RE: 16668 Shannon Road

I reviewed the drawings, and evaluated the site context. My comments and recommendations are as follows:

EXHIBIT 7

THE SITE: Current Photo

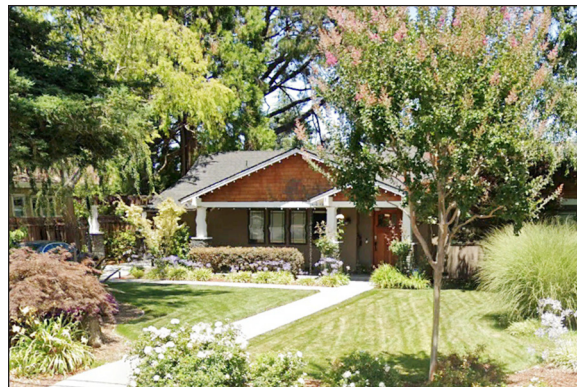
6. Add substantial landscaping in the driveway island similar to that which previously existed - see top two photos on page 2 and the aerial photos on page 3. This will buffer views to the larger home entry element, and bring the design back into compliance with Residential Design Guideline 2.4.4.

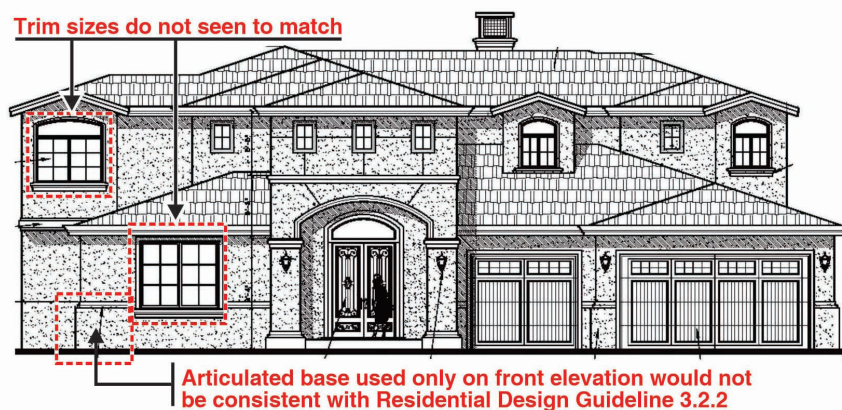
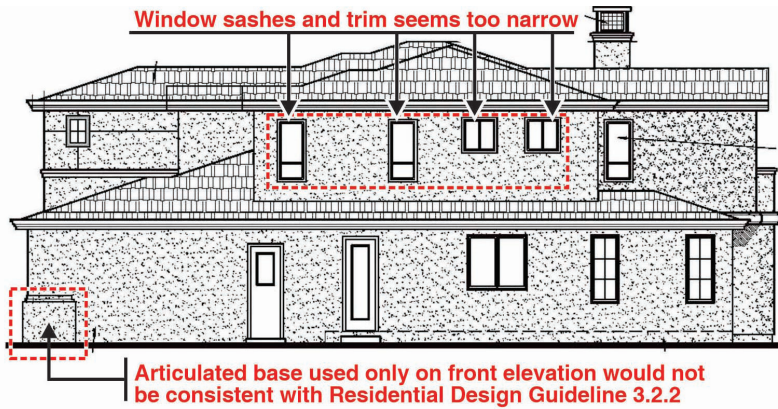
The overall eave and ridge heights of the house would be similar to other new two-story homes in the immediate neighborhood - see streetscape comparisons below.

The proposed design would have taller elements near the front setback line than the other new larger homes nearby, but the house would be set back forty feet. The front facade would be softened by substantial articulation, and an emphasis on the first floor roof eave line.

RECOMMENDATIONS

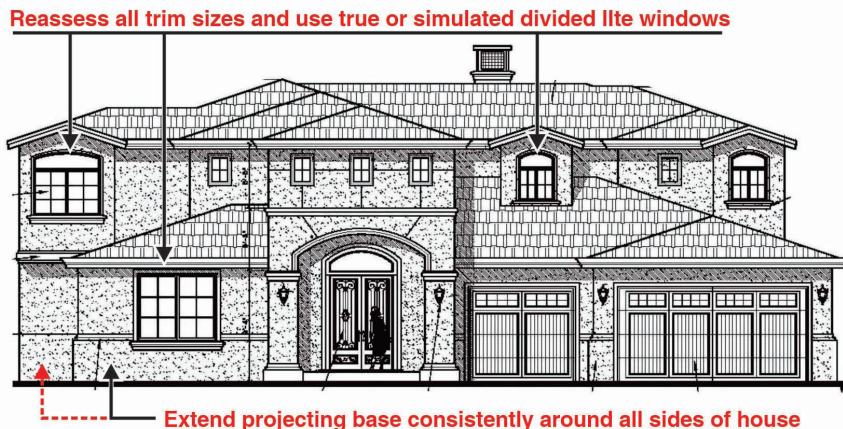
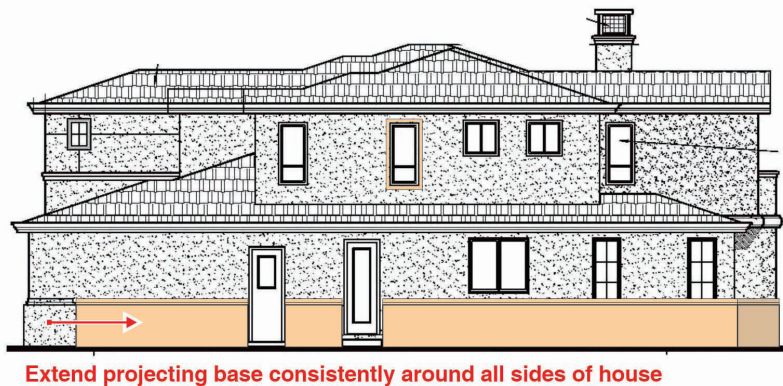
1. The articulated projecting base is appropriate to the architectural style, but does not carry around the sides and rear of the home which would not be consistent with Residential Design Guideline 3.2.2.

- Carry wall materials, window types and architectural details around all sides of the house. Avoid side and rear elevations that are markedly different from the front elevation.
2. Window details are not shown, but from the elevations, there may be some issues.
 - The sash widths appear too small for the scale of the proposed house design.
 - The window trim appears inconsistent, and in some cases too narrow.

1. Extend projecting base consistently around all sides of the house.
2. Select windows that have sash widths consistent with the scale of the house (e.g., vinyl cover wood), and recess windows from the exterior wall face.
3. Reassess all window trim sizes to be consistent, and of a size appropriate to the scale of the house and each window.
4. Consider cast stone trim instead of stucco-covered foam for a higher quality of finish at windows and other projecting trim.
